2610
9.14m LOTS
GARDEN 4 (GR)
ELEVATION 1,2 & 3
A1 PACKAGE
O.REG. 332/12

TITLE SHEET
BARLASSINA CONSTRUCTION
CITY OF CAMBRIDGE

CITY OF CAMBRIDGE
BUILDING DIVISION

THESE PLANS have been examined for compliance
with the Ontario Building Code Requirements. A
Building Permit is in Order to issue subject to any
changes noted under the condition that the building will
be constructed in accordance with the code

REAR ELEVATION 1

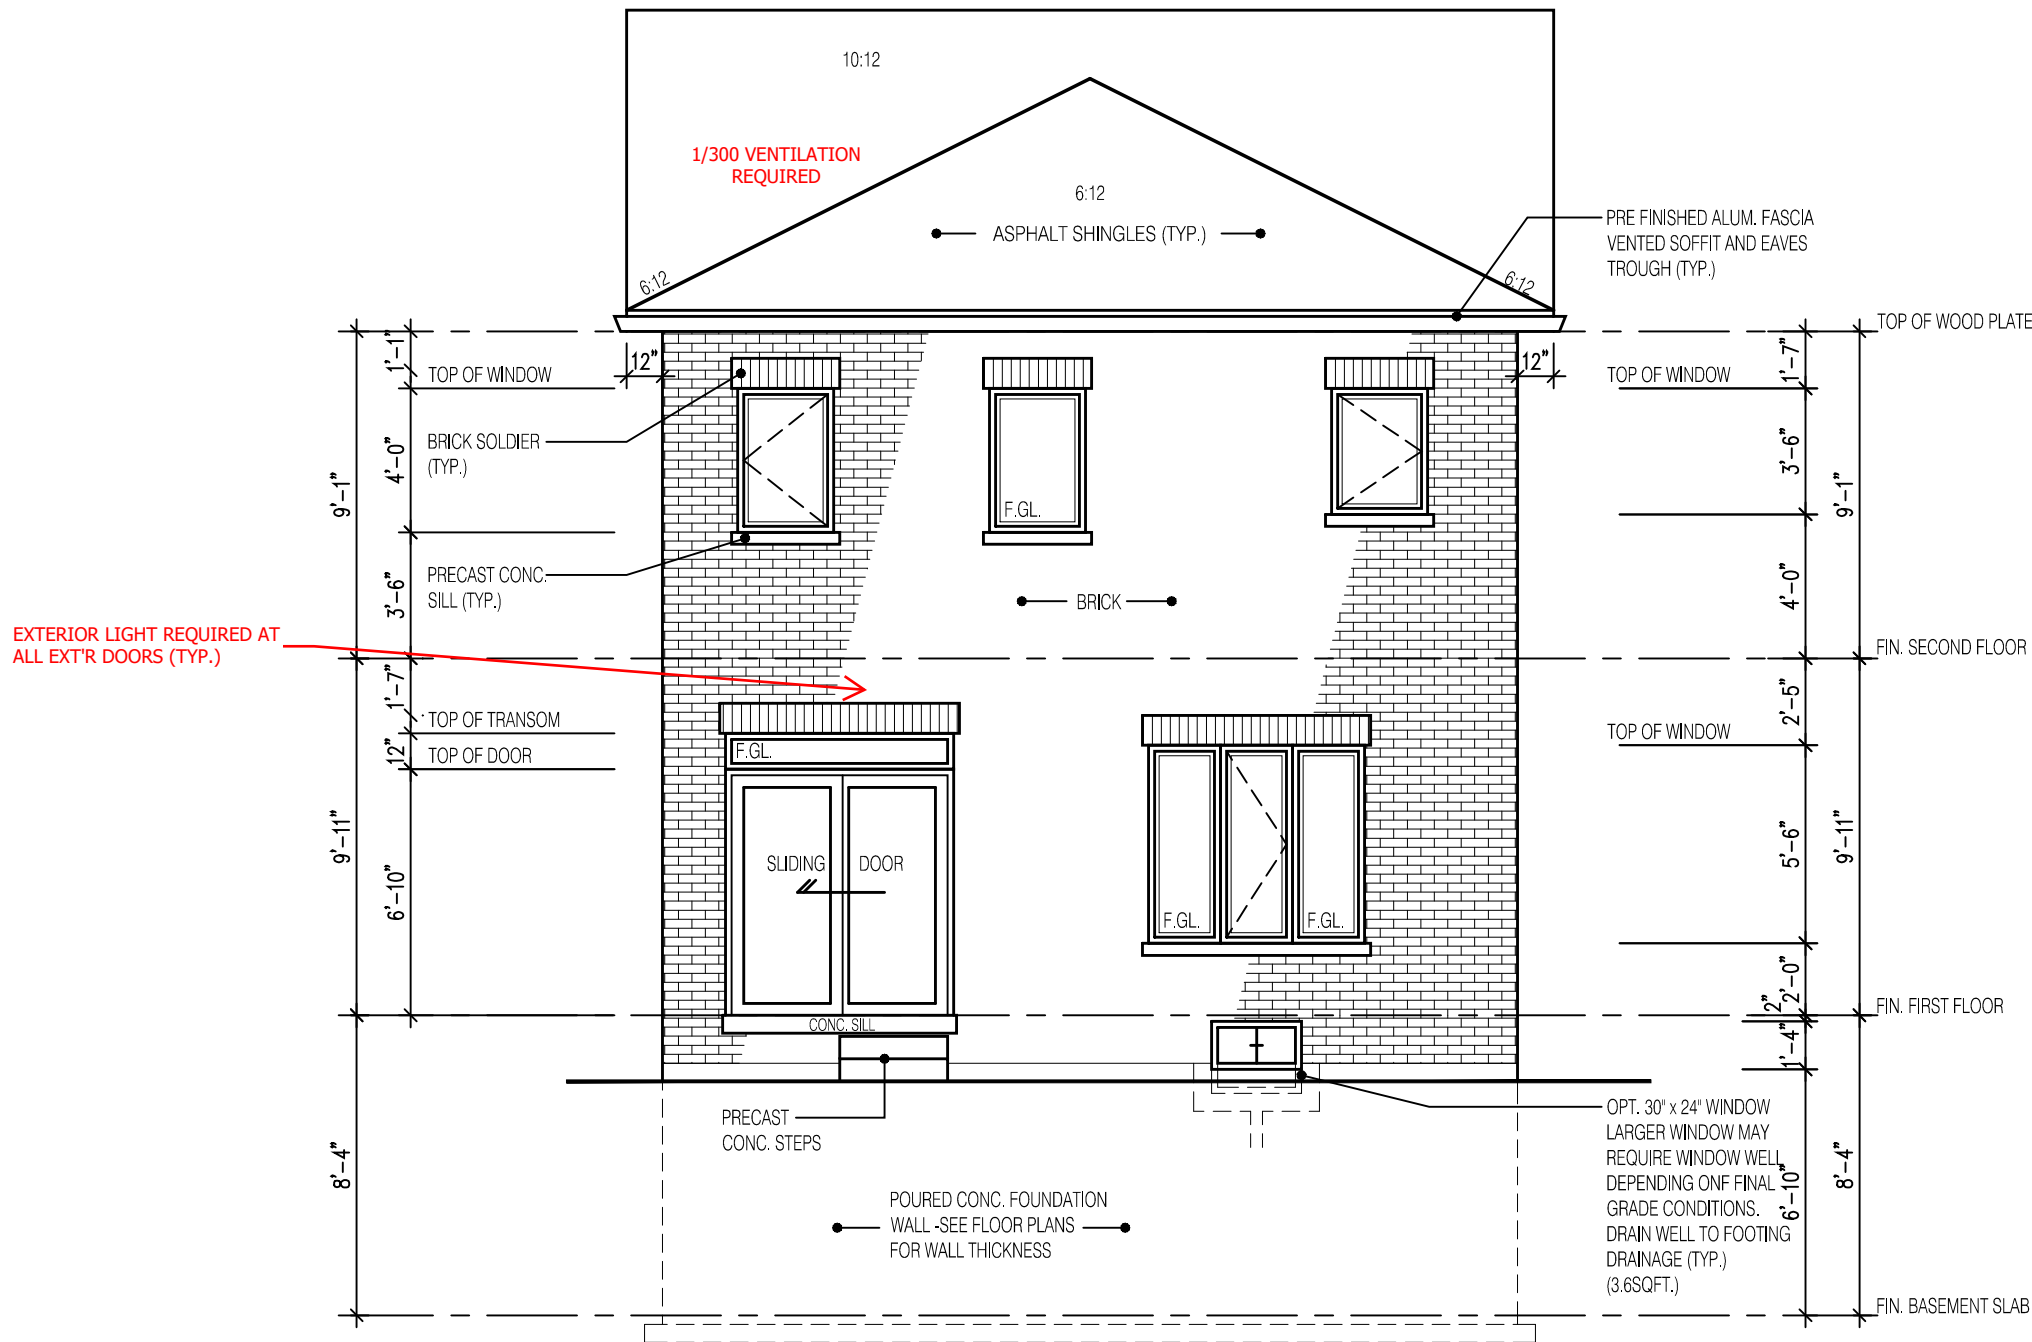
PROVIDE STAIR, GUARD AND LANDING OR
INSTALL PERMANENT BLOCKING TO
RESTRICT DOOR OPENING TO MAX. 4".

EXTERIOR CONCRETE STAIRS w/ MORE
THAN 2 RISERS TO MEET THE
REQUIREMENTS OF 9.8.9.2.(1)

RIGHT SIDE ELEVATION 1

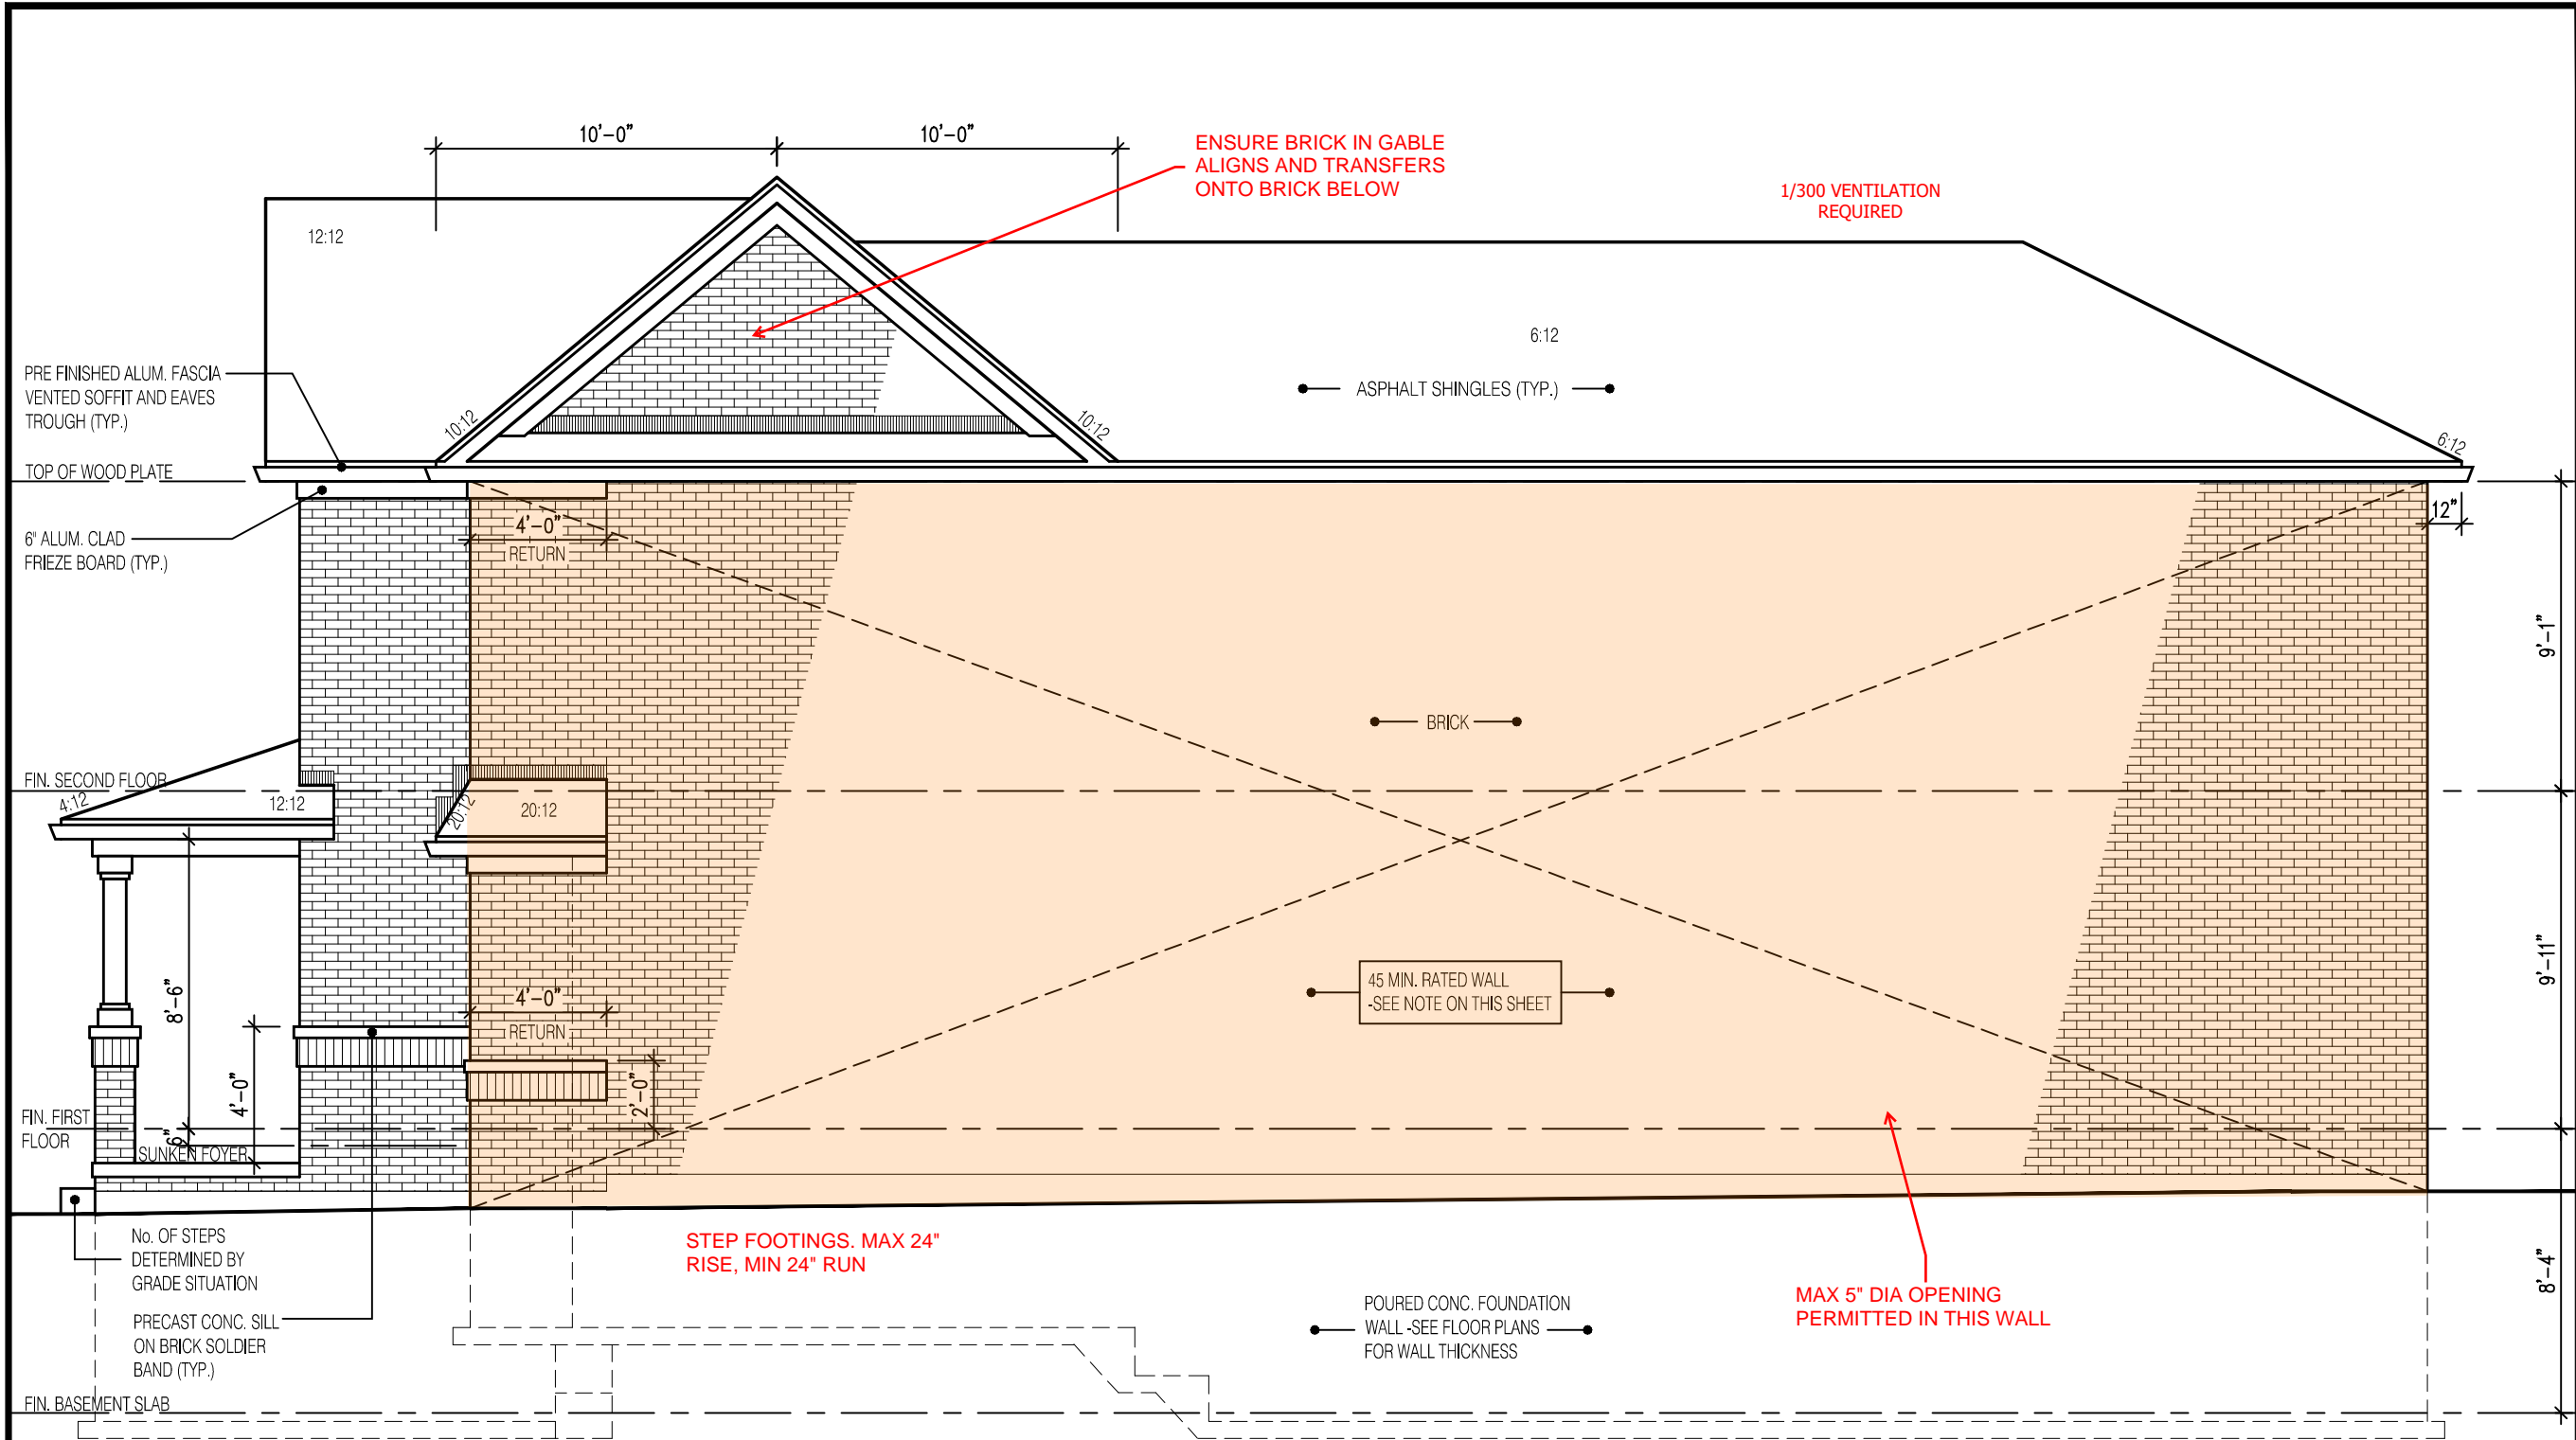
EXPOSED BUILDING FACE REQUIRES A 45MIN F.R.R. w/ 5/8" TYPE "X" DRYWALL & STUDS FILLED w/ INSUL. HAVING A MASS NOT LESS THAN 1.22 KG/M² WHERE LIMITING DISTANCE < 1.2m
